Comments on “Development of Cross-Polar Orientation-Insensitive Chipless RFID Tags”

Abstract— In [1], the authors present a technique for designing resonant scatterers that display a cross-polarization reflection that remains consistent (i.e. non-zero) regardless of the orientation of the target. The authors claim that this property can be obtained simply by duplicating, rotating and arranging the position of a unit cell. We will show in this comment that all the design techniques presented in [1, Sec. III] lead to multiple cancellations of the cross-polarization component of the backscattered E-field. Therefore, the measurement results presented in [1] cannot be justified by the theory presented in section III of the same article.

Fig. 1. Angular coverage of the individual dipoles and of the total unit cell. This figure should be compared with [1, Fig. 3] which uses scalar summation.

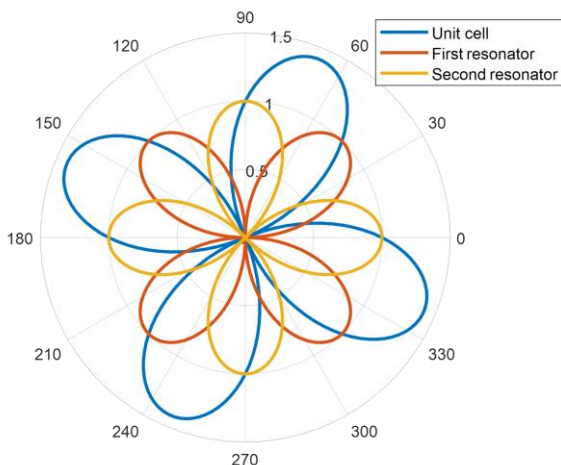
which appears to be zero for $\theta = 22.5^\circ$ [90°]. The graphical representation of $S_{vh}(\theta)$ normalized by A has been plotted in Fig. 1 for comparison with [1, Fig. 3]. The curves are identical for the first and the second resonators but the unit cell exhibits four nulls contrary to the scalar summation presented in [1]. Therefore, the unit cell shows no improvement in terms of angular coverage compared to the individual dipoles.
